ADELL CENTER ROAD AND UTILITIES JSP 18-27

Public hearing at the request of Orville Properties, LLC for Adell Center JSP 18-27 for Planning Commission's recommendation to City Council for approval of a Site Plan for Roads and Utilities, a Wetland Permit, a Woodland Permit and a Site Condominium Plan. The subject property is approximately 22.48-acres and is located at 43700 Expo Center Drive, north of Grand River Avenue and south of I-96 in Section 15. The applicant is proposing to develop the property as a multi-unit commercial development consisting of nine units accessed by a proposed private drive. The existing water tower on site will remain on a separate unit.

PLAN REVIEW CENTER REPORT
Planning Review
ADELL CENTER
Roads and Utilities with a Site Condominium
 JSP 18-27

ADDELL CENTER PHASING PLAN (OVERALL)
43700 EXPO CENTER DRIVE - PARCEL NO. 22-15-476-045
TOWNSHIP 15 N., RANGE 16 E., SECTION 15
CITY OF NOW COUNTY OAKLAND MICHIGAN

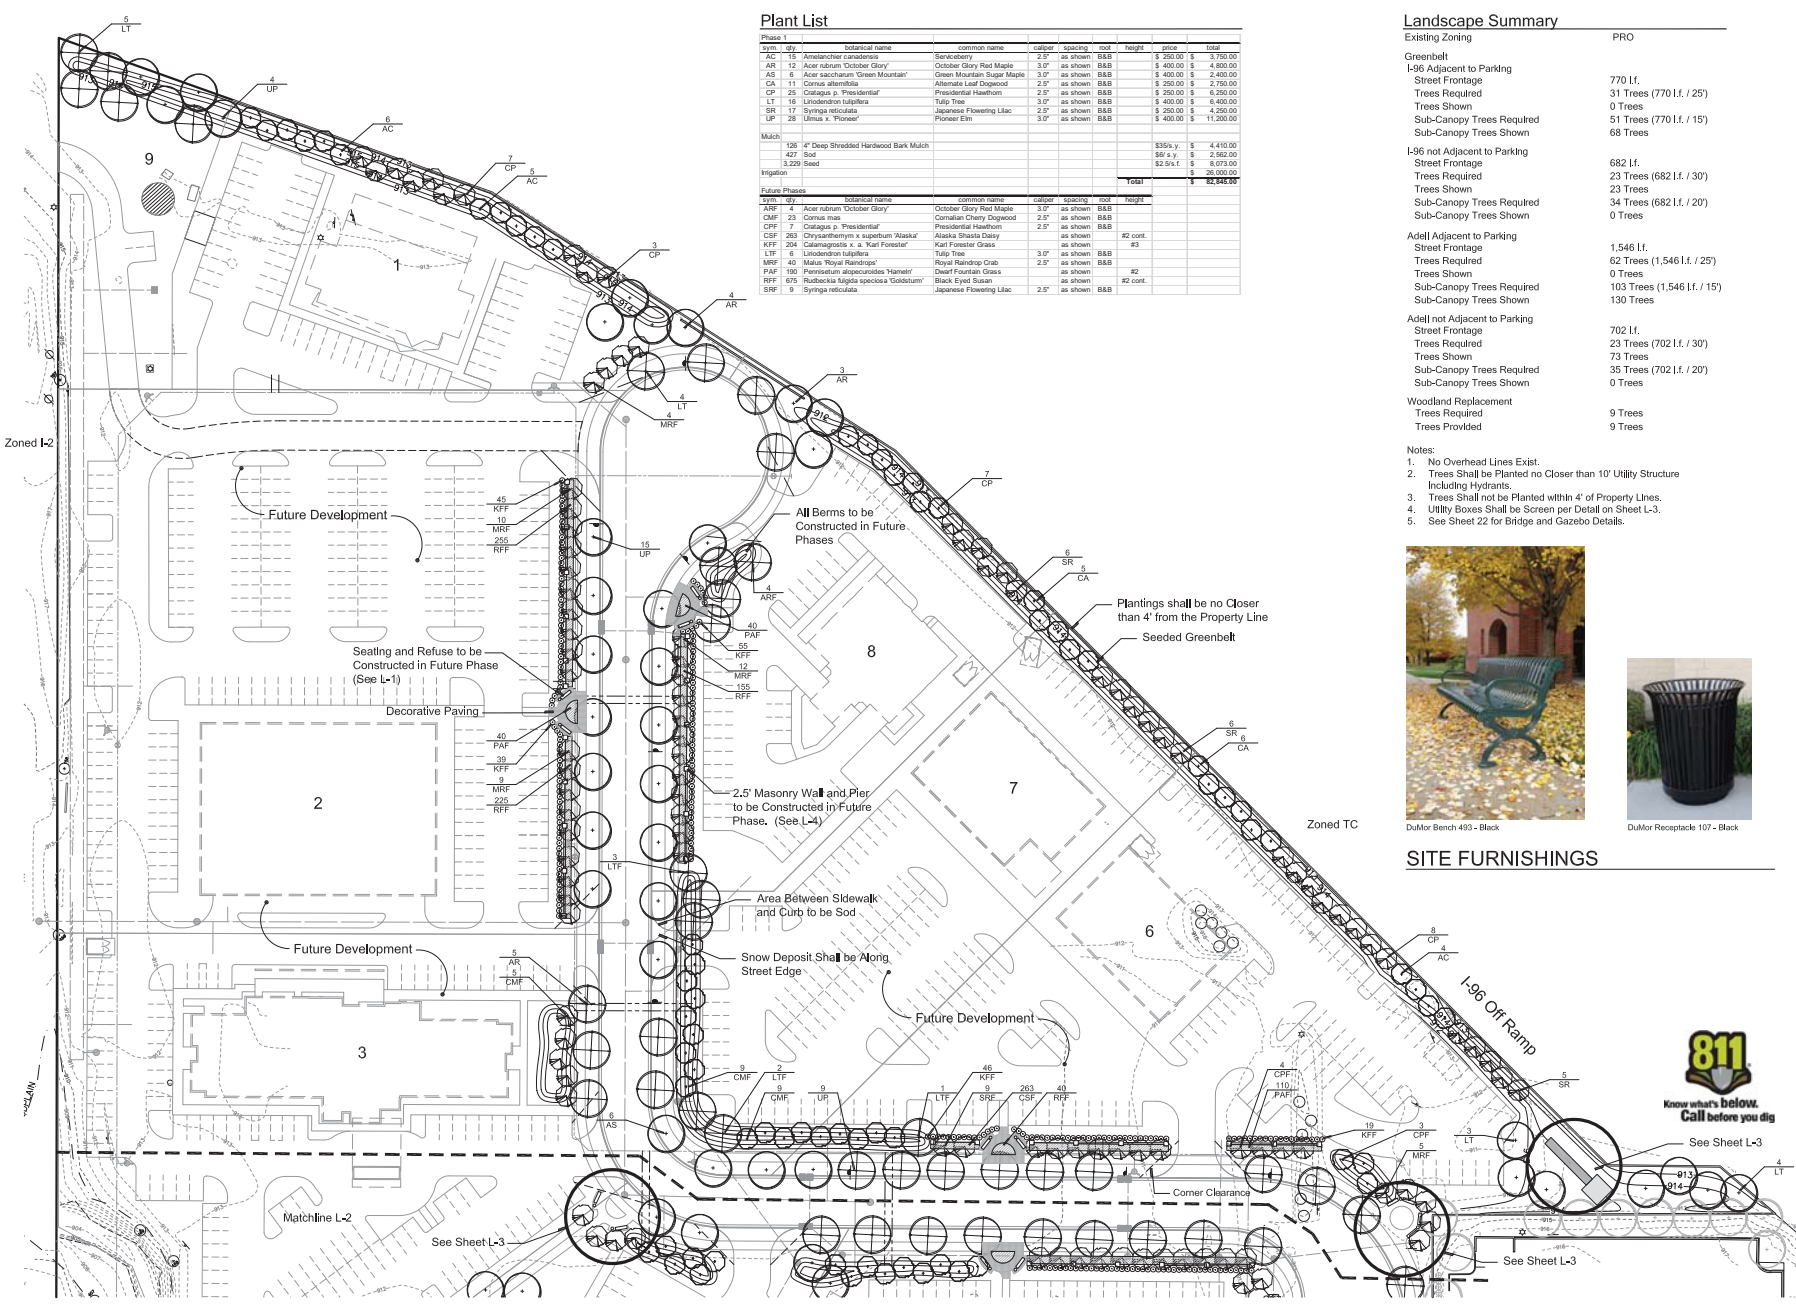
- h. **Gravel Access Drive:** The applicant is proposing a gravel emergency access driveway, per sheet 12. The use of gravel, instead of hard surface such as concrete or asphalt, would require a variance. The timeline for paving the access in the event Unit 2 is not completed within a certain period of time should be addressed in the PRO agreement.

4. The applicant has proposed a 20 foot wide emergency access drive at the end of the cul-de-sac. This width does not match the 16 foot width on sheet 2 of the Paving Standard Details.

- a. Sheet 10 indicates it is a gravel driveway, however, the detail on sheet 2 of the standard paving details indicates HMA.
 - b. The applicant should include the appropriate signing and emergency access gate per Figure VIII-K of the City's Code of Ordinances.

Title:
Landscape Plan
 Phase 1

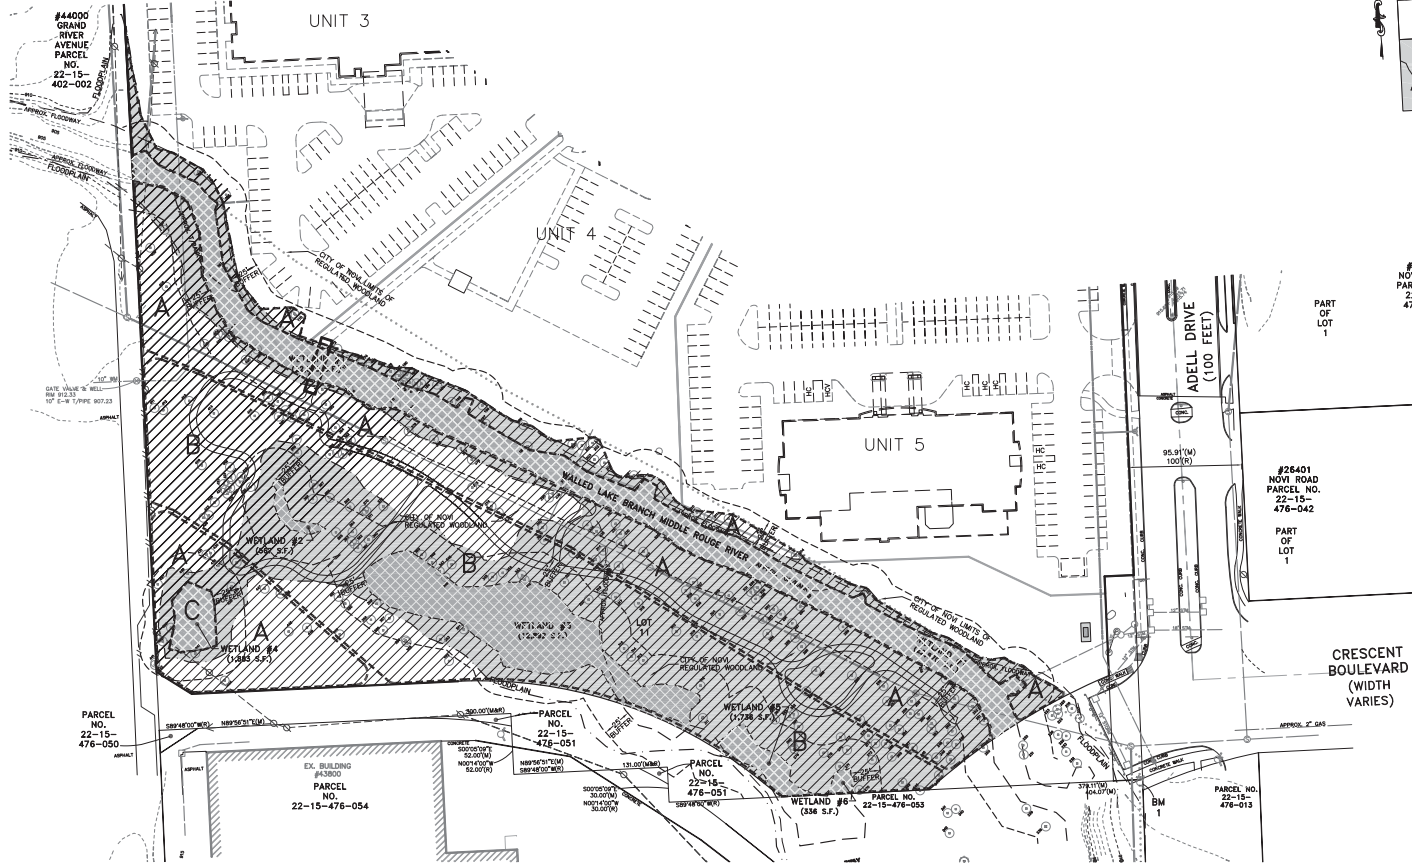
1. Please add call-outs on Sheets L-1 and L-2, labeling each Focus area with the area label shown on L-3 and making clear that they will be constructed as Part of Phase I.
2. Please remove the landscaping that is not part of the Road & Utilities Construction from these plans.

1. Please add call-outs on Sheets L-1 and L-2, labeling each Focus area with the area label shown on L-3 and making clear that they will be constructed as Part of Phase I.
2. Please remove all future plantings from these Landscape Plans to avoid confusion.

Figure 2. Wetland Sketch (provided by BWA).

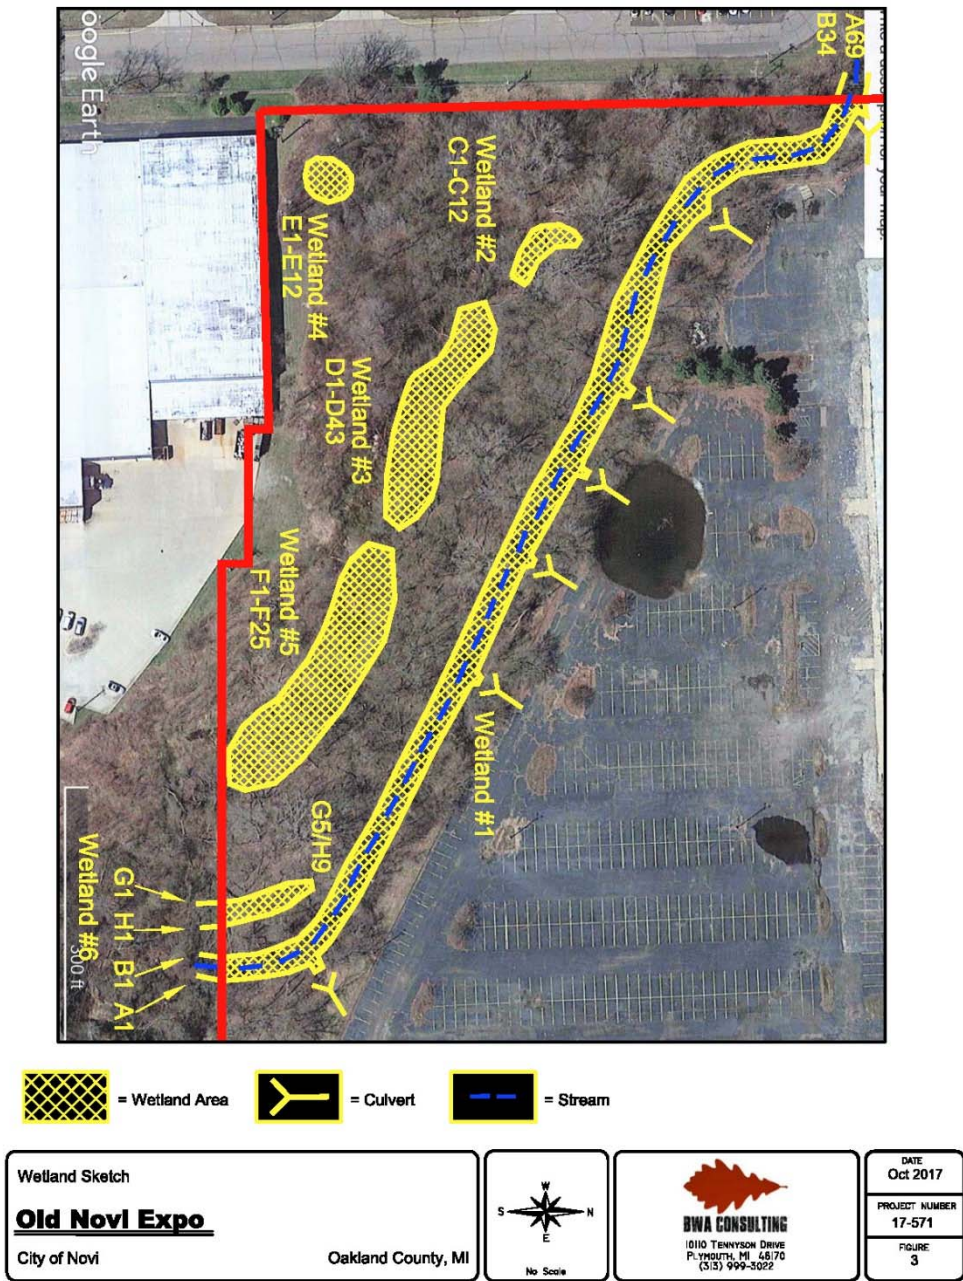
ECT has evaluated the on-site wetlands and believes that they are all considered to be essential/regulated by the City of Novi as they meet one or more of the essentiality criteria (i.e., functions and values) outlined in the City of Novi Wetland and Watercourse Protection Ordinance and regulated by the MDEQ . As noted, the wetlands appear to accurately flagged in the field and appear to be generally indicated accurately on the *Wetland Sketch* provided by BWA (Figure 2, attached).
